**Response to Comments on the Draft Final Design for PCMC**  
**Mark Fitch, University of Missouri-Rolla**

**General Response:**

Comments by David J. Reisman, USEPA ORD ETSC: Mr. Reisman’s comments showed insight and understanding, and ORD offered a great critique. I have tried to excerpt major points from the comments (quoted in italics below) and address them in order.

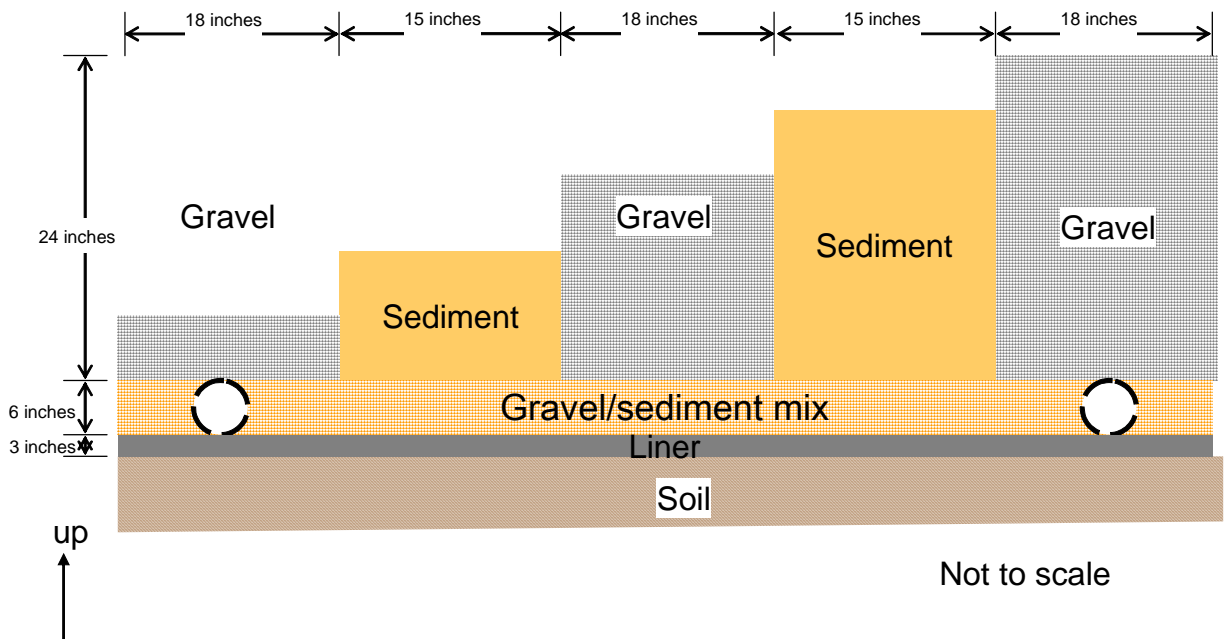
31. *Feasibility in terms of construction and operation & maintenance, with specific questions about how the alternating layers of gravel and active biological “substrate” will be laid down.* The suggested construction method is to lay down a short lift, 4-6 inches deep, illustrated below. During construction, the various levels will be ziggurat-like, and strings can mark the edges of each lift/layer. A skid loader or small dozer (something with a 5-6 foot reach with a bucket) can pour the material (gravel or mixed substrate) onto the layer followed by manual dress up to roughly level that layer. The individual lifts will slump only a small amount because the exposed height is only a few inches.
